RE: BULK VARIANCE APPLICATION FOR JEFFREY WEAVER

Zoning: R-1
2351 Clifford Avenue
Block 1605, Lot 11
Waterford Township, Camden County, New Jersey
(KEI#41-5WT0320)

End of Clifford Subject Property To Right Private Drive on Left

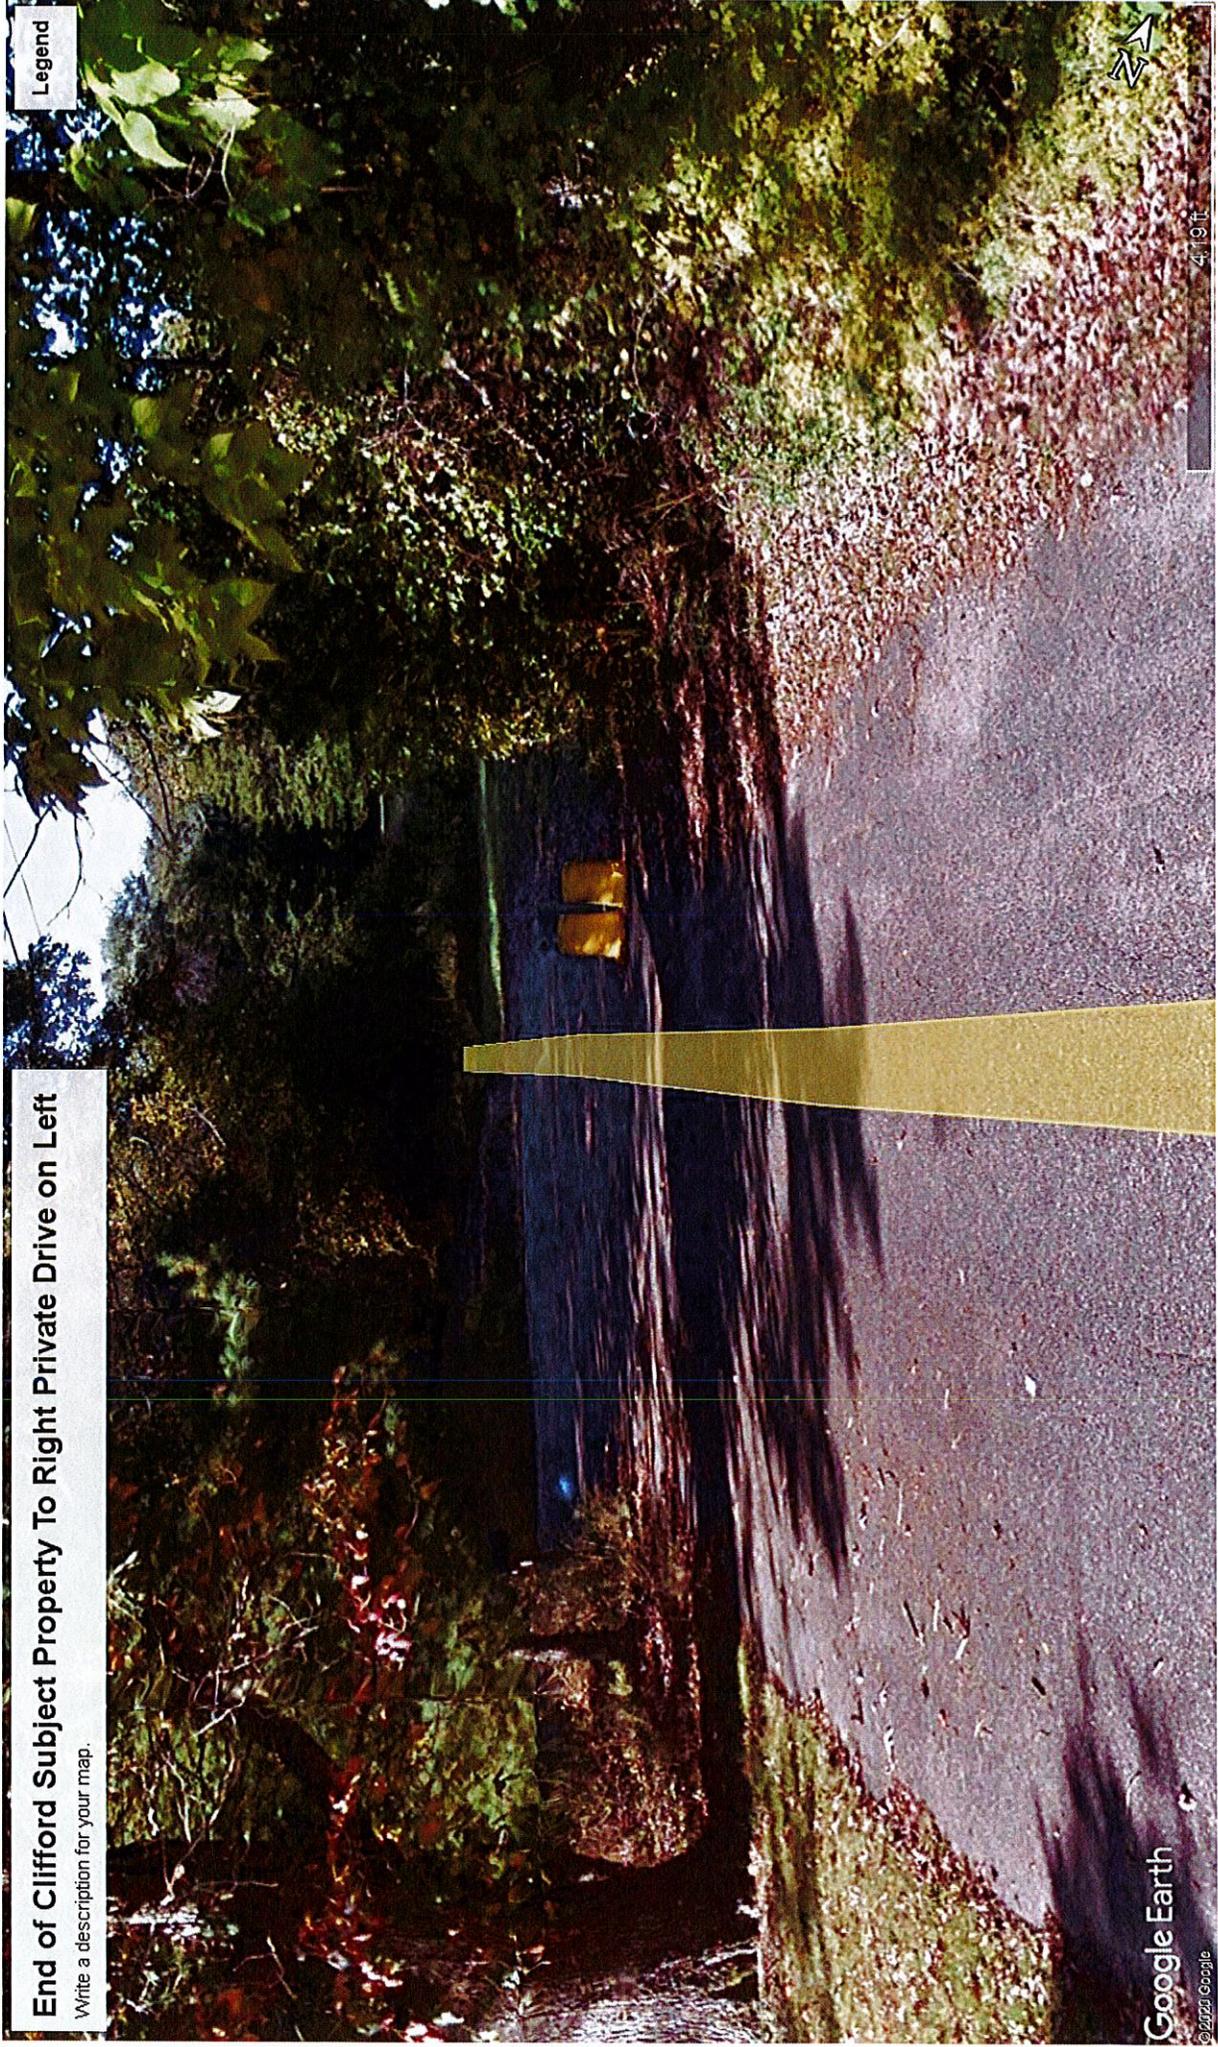
4. I visited and photographed the site on March 2, 2020 and noted that the property is at the physical end of Clifford Avenue. A "NO OUTLET" sign is placed on Clifford at its intersection with Fifth Street.

The roadway is approximately 20' wide and is in fair condition. It is paved for just a few feet past the subject property and ends at an abandoned driveway previously serving Block 1606 Lot 1. The area is now vegetated with brush. The roadway then bends to the southwest, becoming a private driveway serving a home on Block 1606 Lot 1. There is no signage indicating that the private driveway is in fact a private driveway. There is monolithic concrete gutter along the private driveway and there is a mailbox at the commencement of the driveway. There is very limited ability to turn a vehicle around at the end of the Clifford Avenue because the road simply ends in brush and trees. Once a home is constructed, the applicant would have

the ability to turn around in his own driveway. However, trash trucks, fire trucks, delivery trucks and emergency vehicles and any other similarly large vehicles would be forced to back out of or into the area for a distance of about 500' to Fifth Street to exit the area. This is the existing situation for the homes currently existing on this section of Clifford. A Google Street View image and (1) of our site visit photos are attached to illustrate this issue.

We recommend that an area be constructed at the physical end of Clifford, within the municipal right-of-way to provide the ability for a vehicle to turn around as is required by the Residential Site Improvement Standards, specifically NJAC 5:21-4.2 m. This section provides criteria for either cul-de-sacs or hammerhead type turn-arounds. Since the road sees very little traffic volume, serving only (4) existing homes, the turn-around area could be surfaced with a dense graded aggregate material. The final cross section and grading could be determined by the applicant's engineer and be subject to review and approval of the Township Engineer. The provision to address this situation should be made a condition of any approval.
